Re: Request for Additional Information - Greenhouse Gas Emissions

I refer to Department of Planning, Housing, and Infrastructure's (DPHI) Request for Information (RFI) dated 11 March 2024 received in relation to HVO North (SSD 11826681) and HVO South (SSD-11826621). The RFIs sought the following additional information:

Figure 1 HVO Scope 1 Project Emissions Profile vs Indicative Baselines¹

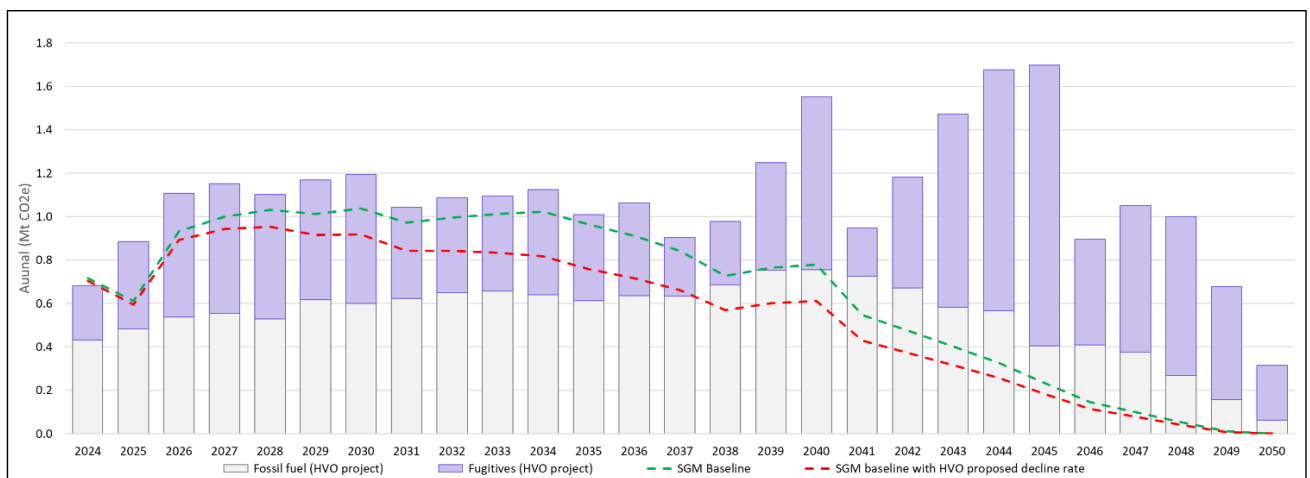
RFI: Consideration of the Climate Change (Net Zero Future) Act 2023, including the NSW emissions reduction targets and guiding principles

Figure 1 depicts the Project's Scope 1 emissions profile (columns) in comparison to the Project's Federal SGM baseline (green dashed line), and the proposed net GHG emissions for the Project (red dashed line) to reflect the additional contribution proposed by HVO.

Table 1 details HVO's proposed decline rates for its net emissions.

Financial Year beginning	National Greenhouse and Energy Reporting (SGM) Rule 2015 – decline rates as per Clause 32 (result in the green dashed line)	HVO Proposed Decline Rates for HVO Project (result in the red dashed line)
1 July 2023 to 1 July 2029	4.9%	5.9%
1 July 2030 to 1 July 2034	3.285%	4.0%
1 July 2035 to a later 1 July	3.285%	2.58%

Figure 3 HVO Scope 1 Project Emissions Profile vs Indicative Baselines (including Safeguard baseline plus 30%)

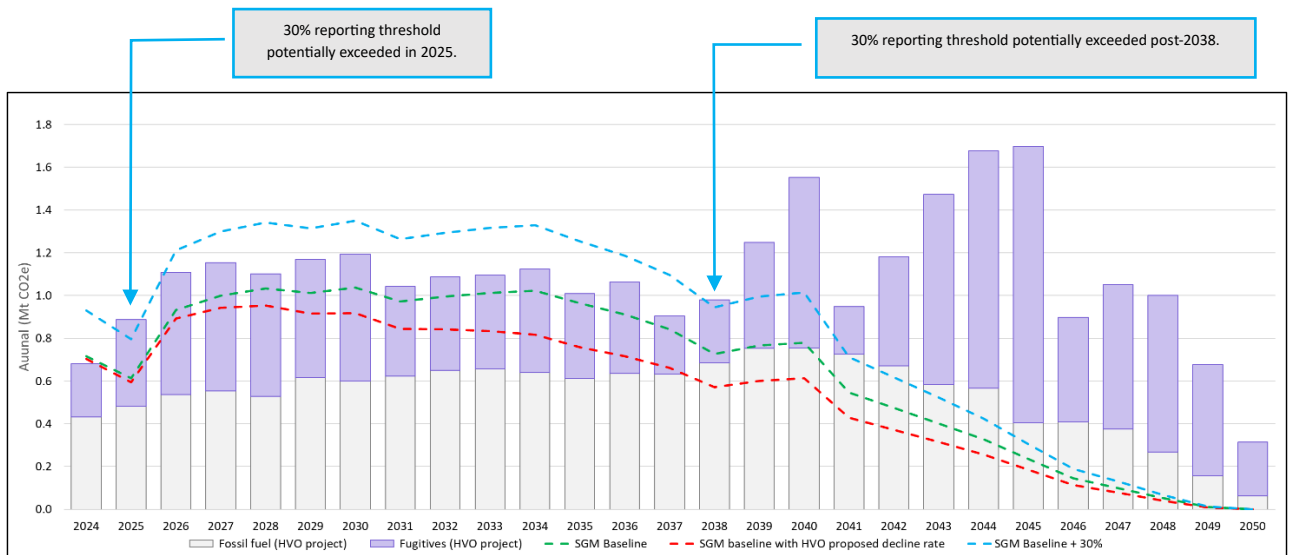
RFI: Consideration of the reporting requirements under the Commonwealth Safeguard Mechanism for a facility proposing to offset more than 30% of its baseline, including when the project would trigger these requirements and how much above the 30% would need to be offset.

If the Project is unable to adopt technically and commercially feasible emissions reductions, then we forecast that Scope 1 emissions would initially exceed 30% of its Safeguard Baseline in 2025, but then would not trigger this reporting threshold again until 2038. Over the 2038 to 2050 period (assuming no new technically and commercially feasible emissions abatements are then available), the HVO Project may exceed the Safeguard Baseline + 30% reporting threshold by a total of ~8.8MtCO₂e.

Figure 3 depicts the Project’s Scope 1 emissions profile (columns) in comparison to the Project’s Federal SGM baseline (green dashed line), the proposed net GHG emissions for the Project (red dashed line) to reflect the higher decline rates proposed by HVO, as well as the 30% baseline exceedance trigger for an explanation requirement (blue dashed line).

Figure 4 Estimate of Equipment Purchase (Year 1 is 2025)

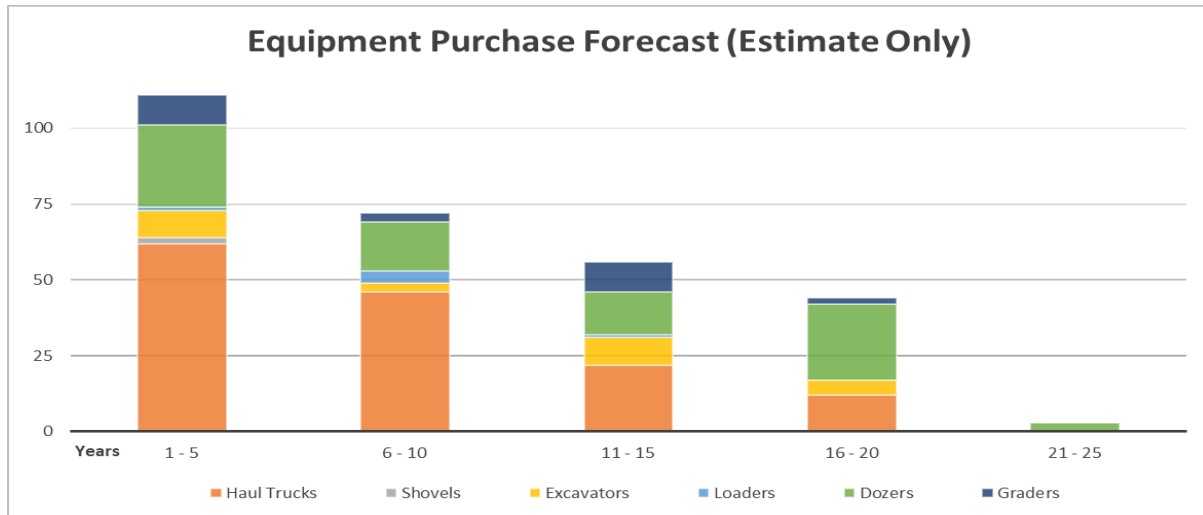
RFI: Indicative schedule of fleet replacement over the life of the project, in 5-yearly increments, to better understand the likelihood of implementing new technologies as they become available

Below is a graph (**Figure 4**) of forecast equipment replacements for the duration of the proposed mining schedule. Note that this forecast is an indicative estimate only. It is based on the known assumptions at the time of EIS preparation. It has been developed considering current expectations for chassis life, engine life, overhaul costs and new equipment purchase costs. It has not factored in developments in technology either for

Figure 4 above shows that there are considerable fleet replacement purchases scheduled throughout the life of the Project. Each one of these purchases is an opportunity to upgrade to the latest technology to reduce emissions. The practicality and economic value of the technology at that time will be key considerations in the purchase evaluation of the options. Another key factor in the economic assessment of alternatives will be the cost of carbon e.g. the cost of ACCUs. Additionally, as discussed previously, the productivity or efficiency value of new equipment could bring forward the anticipated equipment replacement timing.
